N19 Shannon Airport Access Road Improvement Scheme

ROAD SAFETY AUDIT STAGE F – Part 1

N19 Shannon Airport Access Road

ROAD SAFETY AUDIT PHASE 2 STAGE F2

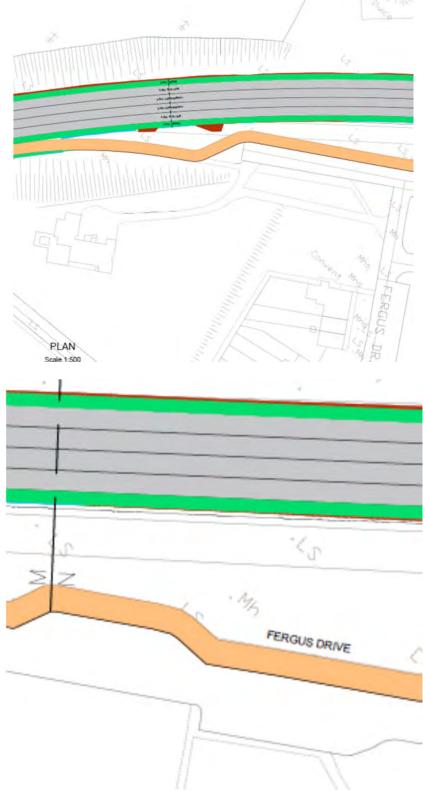
2.1 **Problem**

A shared facility for pedestrians and cyclists is proposed. Shared facilities result in reduced quality of service for both modes and may lead to injury collisions between cyclists and pedestrians.

Recommendation

Provide segregated facilities with a two-way cycle path and a footpath.

2.1	Y	N	Will provide segregation between footpath and cycleway at detail design. Widths to be determined at detail design stage.	YES
2.2	Y	Y		
2.3	Υ	Y		
2.4	N	Y	Existing crossings are not at specific desire lines. The proposed crossings are being provided close to existing junctions to ensure they are embodied in the traffic controls of the junction and will be designed to give priority to VRU. The locations will be reviewed during detailed design in Phase 3 to ensure an adequate number of crossings are provided and they cater for pedestrian and cycle demand and are located where required.	YES

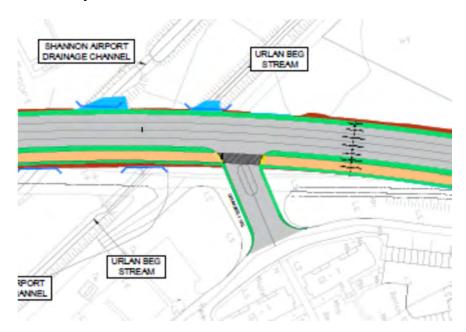
2.7 Problem

The approach to the proposed traffic signals at Drumgeely junction is on a sweeping right-hand bend. Planting on the existing median, if retained, could block visibility for an approaching driver such that stationary traffic queued back from the signals might not be seen in time. This could increase the risk of rear-end collision.

Recommendation

Ensure that drivers are provided with the required Stopping Sight Distance.

2.6	Y	Υ		
2.7	Y	Υ
